Appendix A: HAL NC2022-01 Platform Gap Filler Fixings for use by Class 387 and Class 345 at Heathrow Central, Heathrow Terminal 4 and Heathrow Terminal 5 stations.

1. Introduction

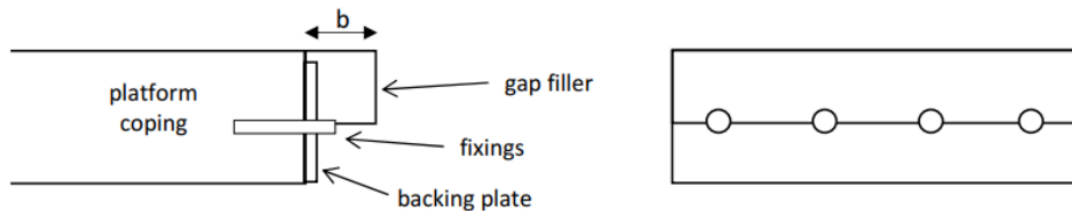
To install the new PGFs, the existing gap fillers must be removed along the entire length of the platforms by removing the bolts.

The specification for the proposed bolt fixing design for the new platform filler:

- Serviceability loading: 2kN point load (Category C36 from BS EN 1991-1-1:2002)
- Bolt size (min.): Hilti HAS-U M10 Grade 8.8 bolt (or equivalent approved), with minimum 100mm embedment into concrete coper.
- Recommended resin for bolt installation: Hilti HIT HY-200 minimum specification (or equivalent)
- Minimum edge distance to any free edge of the coper (whether exposed or covered): 20mm (based on 2 x bolt diameter and concrete shear stress).
- Where only 3 bolts can be installed along a PGF as per fixing application case scenarios, these must be installed at the end fixings of the PGF.

Where 4no bolt fixings are installed, all bolts must be installed as per case scenario requirements detailed in Section 4

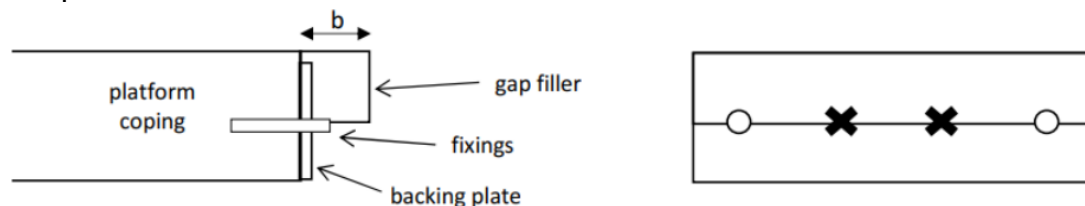
Where 3no bolt fixings are installed, the omitted fixing is permissible for either of the inner bolts only. End bolts must not be omitted.

Where 2no bolt fixings are installed, the inner bolt fixings may both be omitted if required.

The below drawings are examples of the Delkor platform filler.

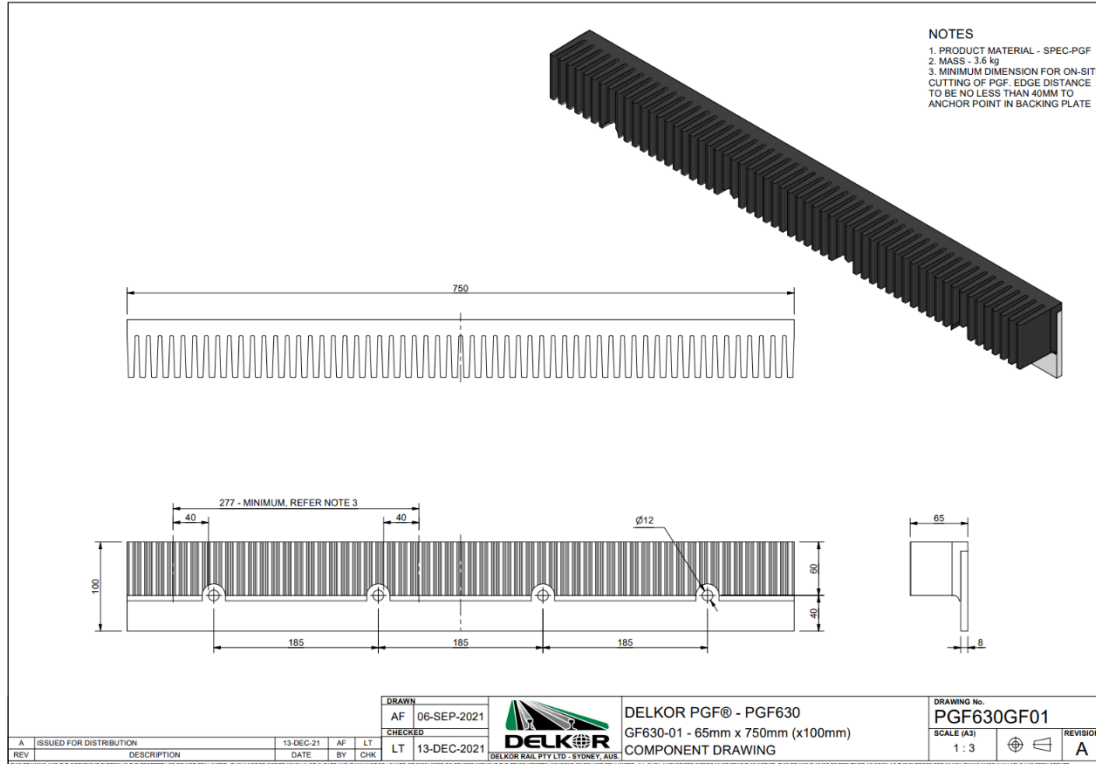
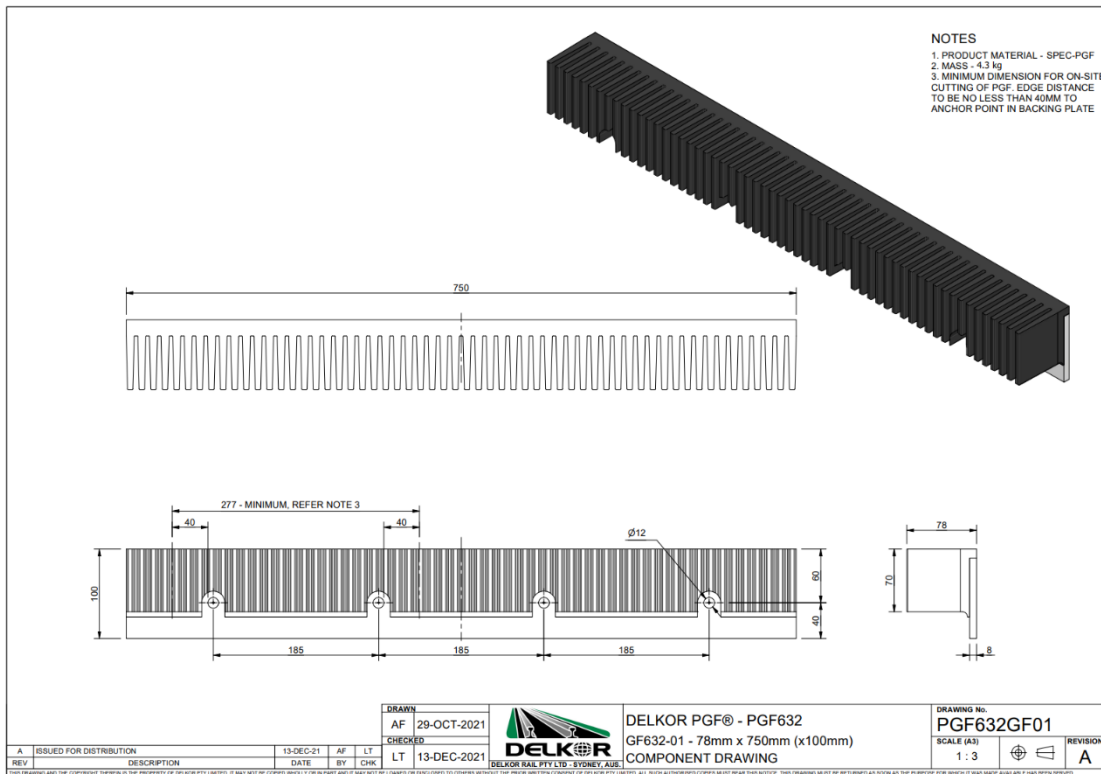
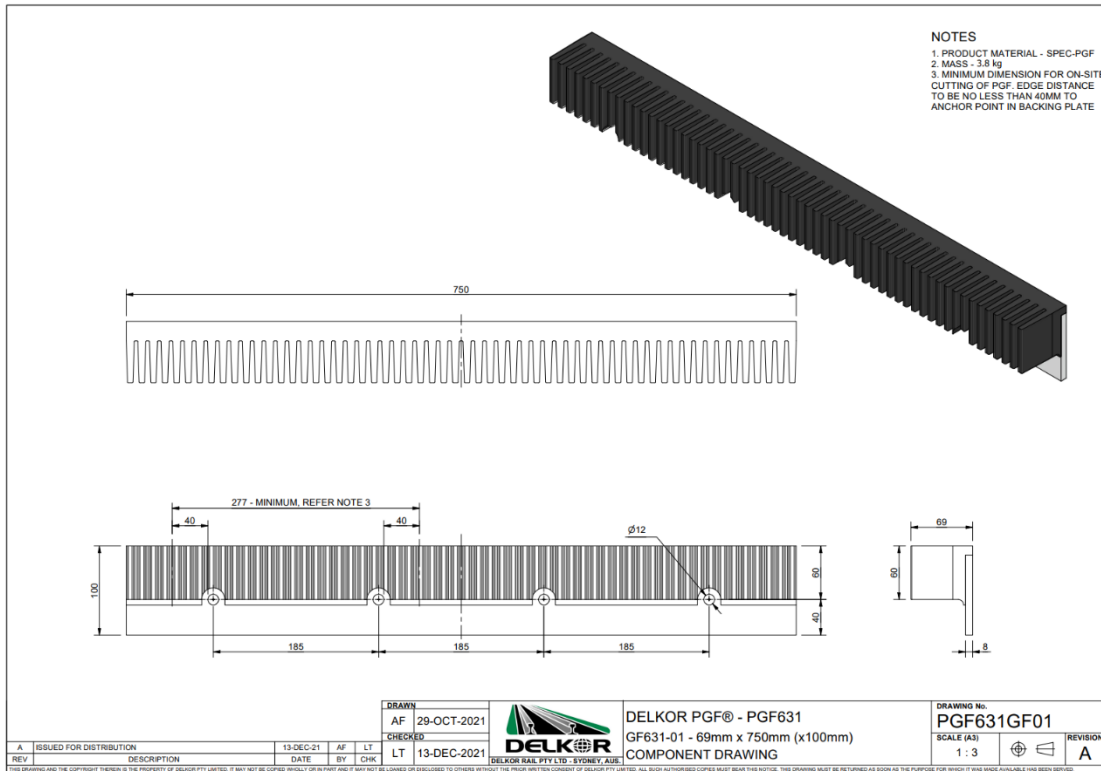
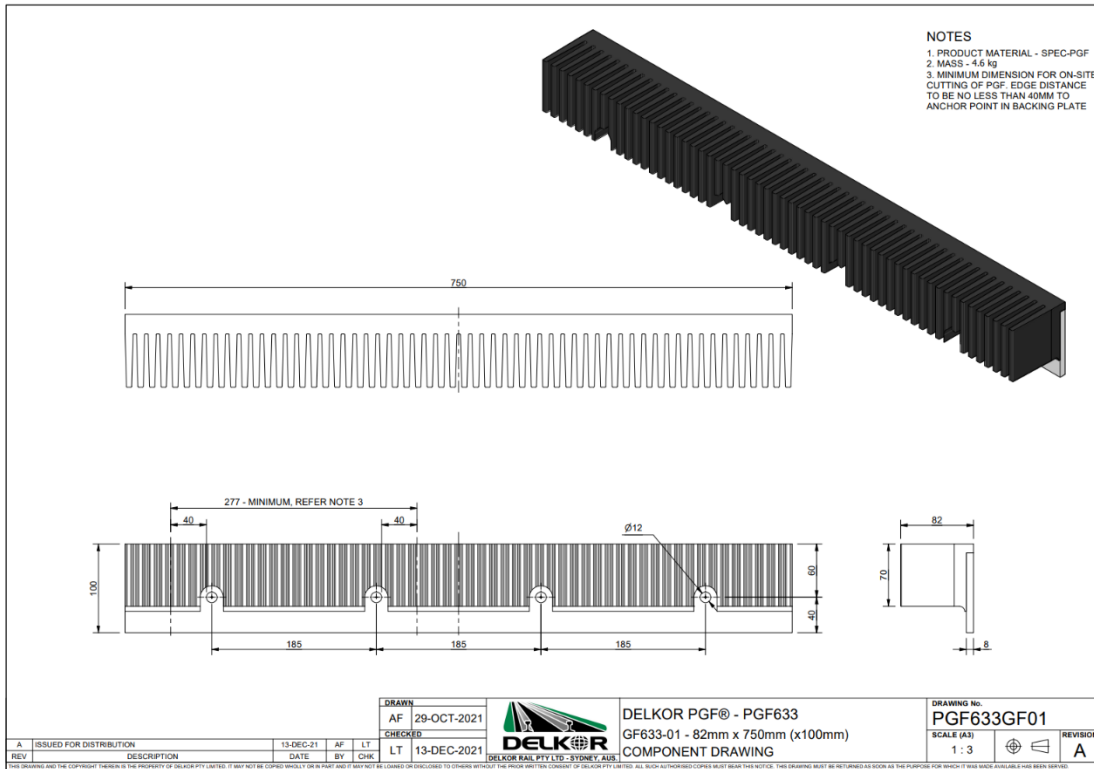
Site name	Gap filler total width	Delkor drawing reference number
Heathrow CTA Terminal 3 Platform 1	78mm	PGF632GF01
Heathrow CTA Terminal 3 Platform 2	82mm	PGF633GF01
Heathrow Terminal 4 Platform 1	78mm	PGF632GF01
Heathrow Terminal 4 Platform 2	82mm	PGF633GF01
Heathrow Terminal 5 Platform 3	65mm	PGF630GF01
Heathrow Terminal 5 Platform 4	69mm	PGF631GF01
